## **Proposal for supplement 4 to UN Regulation No. 134 (Hydrogen and Fuel Cell Vehicles)**

### **Submitted by the expert from the Netherlands**

#### **Provisions for a label for compressed hydrogen vehicle of categories M<sub>2</sub> and M<sub>3</sub>.**

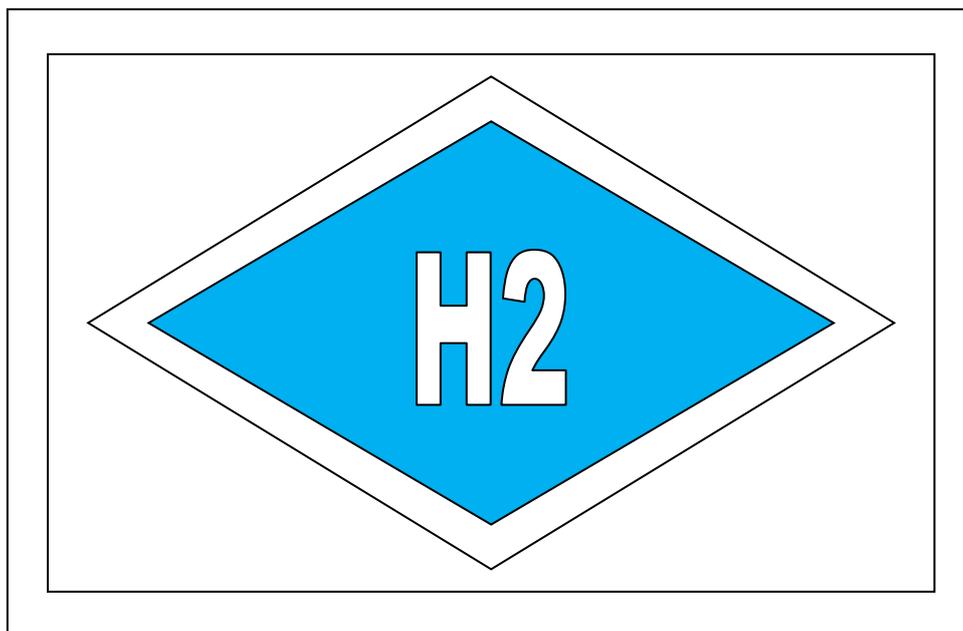
**7.1.7.1. On vehicles of the categories M2 and M3, equipped with a compressed hydrogen system, labels shall be installed as specified in Annex 6**

**7.1.7.3. A label shall be placed adjacent to the H2 fill receptacle; for instance inside a refilling hatch, showing the following information: fuel type (using label shape and zones, colour definitions and pictogram as designated in Annex 6, MFP, NWP, date of removal from service of containers."**

The label consists of a sticker which shall be weather resistant.

The colour and dimensions of the sticker shall fulfil the following requirements:

Colours:

Background:	Light-blue
Border:	white or white reflecting
Letters:	white or white reflecting

Dimensions:

Border width:	4 - 6 mm
Character height:	≥ 25 mm
Character thickness:	≥ 4 mm
Sticker width:	110 - 150 mm
Sticker height:	80 - 110 mm

The Characters “H2” must be centred in the middle of the sticker.”
